From: [Jonathan Sanders](#)
To: [Soo, Kit, Env. Health](#); riaz@riazinc.com
Cc: [Jonathan Law](#); [Trent Weise](#); [Roe, Dilan, Env. Health](#)
Subject: RE: RO0003183 - Lucasey Manufacturing Site 2744 E 11th St, Oakland, CA - Confirmation Sampling Work Plan - Conditional Approval
Date: Tuesday, March 07, 2017 4:56:22 PM
Attachments: [345989 Figure 2_v02_JES.PDF](#)

From: Soo, Kit, Env. Health [mailto:Kit.Soo@acgov.org]
Sent: Tuesday, March 7, 2017 3:33 PM
To: riaz@riazinc.com
Cc: Jonathan Sanders <jsanders@aeiconsultants.com>; Jonathan Law <jlaw@riazinc.com>; Trent Weise <tweise@aeiconsultants.com>; Roe, Dilan, Env. Health <Dilan.Roe@acgov.org>
Subject: RO0003183 - Lucasey Manufacturing Site 2744 E 11th St, Oakland, CA - Confirmation Sampling Work Plan - Conditional Approval

Subject: Confirmation Sampling Work Plan - Lucasey Manufacturing Site 2744 E 11th St, Oakland, CA

Site Map

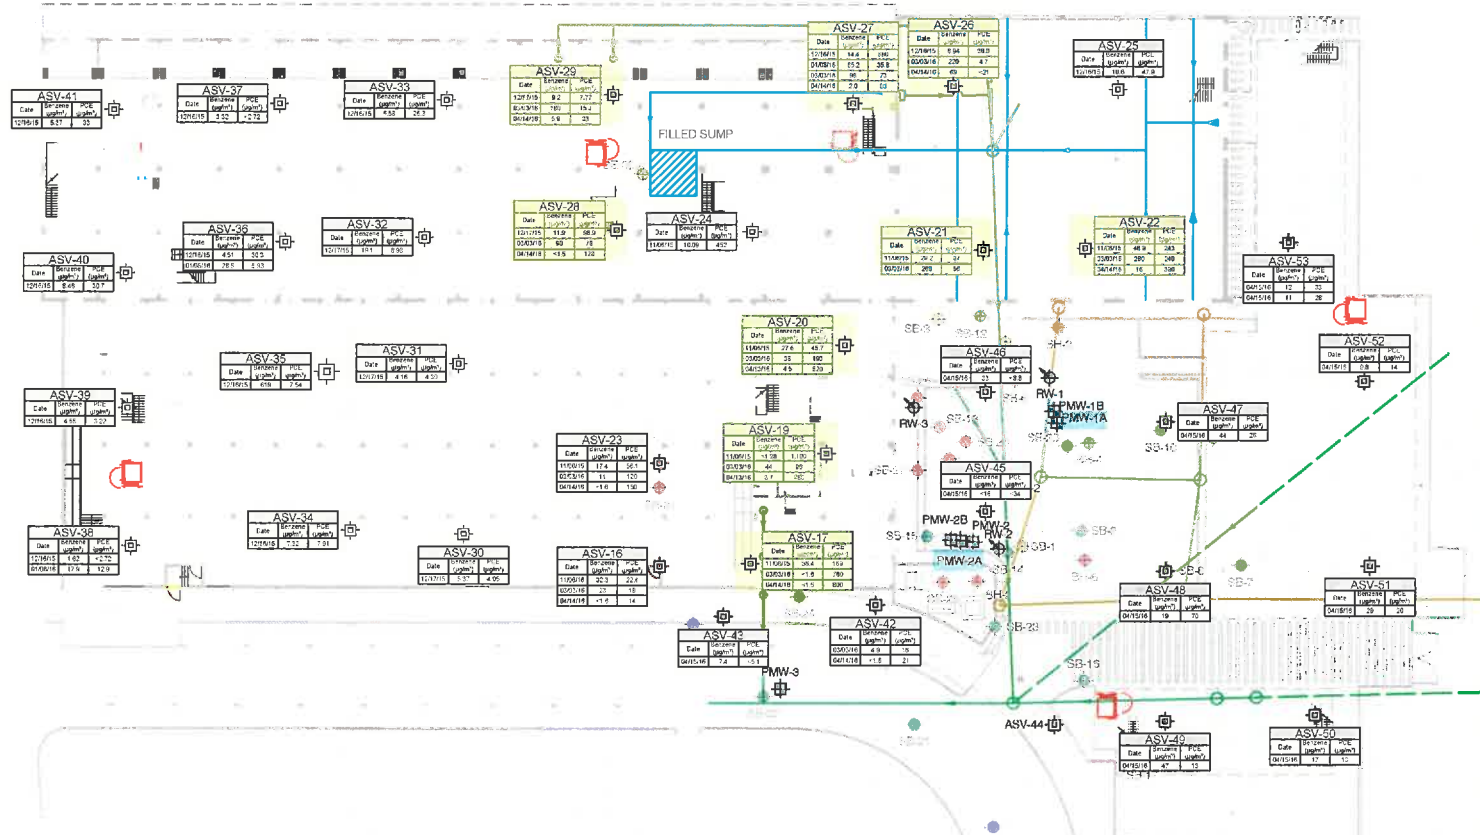
- 1. Groundwater Monitoring and Sampling**
 - Well PMW-3A was indicated but does not appear to be present on Figure 3. Please confirm the ID of the proposed well to be monitored and sampled. Is this supposed to be PMW-3? **This was intended to be PMW-1. We believe that PMW-3 was abandoned by the former owners in fulfilment of the encroachment permit, however we do not have any record of this being the case.**

- Please also monitor all remaining monitoring wells and recovery wells for water levels, and whether non-aqueous phase liquids (NAPL) is present in each of the wells. **Again, we have no record of which wells have been P&Ad, but we will collect DTW and NAPL thickness in each of the wells which are accessible**

- Soil gas probe ASV-27 was indicated but does not appear to be present on Figure 3. Please confirm the ID for soil gas probe ASV-27. **Confirmed. ASV-27 was unintentionally omitted from the previous figure. Please see the attached revised figure for sample location and historic PCE/Benzene concentrations in soil vapor.**

- Please consider sampling the following soil vapor probes as well: ASV-24 and ASV-28. **At your request, ASV-28 will be included in the sampling. ASV-24 was unfortunately a temporary soil vapor probe that was destroyed after sampling on 11/6/2015, as such no additional soil vapor samples can be collected from this location without the installation of a new soil vapor probe which is beyond the scope of the proposed work plan.**

Thank you for taking the time to speak with Trent and I on short notice today. Please see below for AEI's response in **Green**. For the sake of clarity, I have prepared and attached a revised figure depicting proposed sample locations. Please do not hesitate to contact me with any questions.
